Attachment J

**Inspection Report
2-4 Cunningham Street, Haymarket**

Council Investigation Officer Inspection and Recommendation Report; Clause 17(2) Part 8 of Schedule 5 of the Environmental Planning and Assessment Act 1979 (the Act)

**Re: INSPECTION REPORT
'APX HOTELS APARTMENTS – APX WORLD SQUARE'
2 CUNNINGHAM STREET, HAYMARKET ("the premises")**

Figure 1

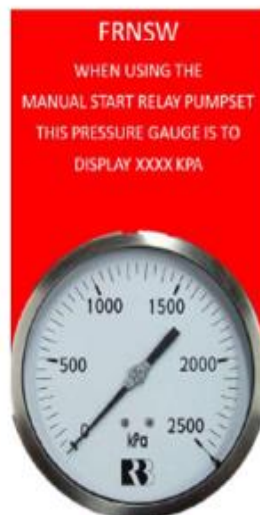
FRNSW position statement '[FRNSW pump performance for high rise buildings](#)' states, the fire hydrant system is to be designed for a 'Boost Pressure' of 950 kPa being input into the fire brigade booster connection from a standard FRNSW pumper, for buildings having an effective height greater than 50 m and requiring a fire brigade relay pump. FRNSW are of the opinion that the boost pressure signage should state, BOOST PRESSURE 950kPa and the relay pump be modified to ensure correct operational pressures.

Additional signage should be installed along with a 150mm pressure gauge similar to *Figure 1*, to advise firefighters of the required pressure at the RELAY PUMP discharge.
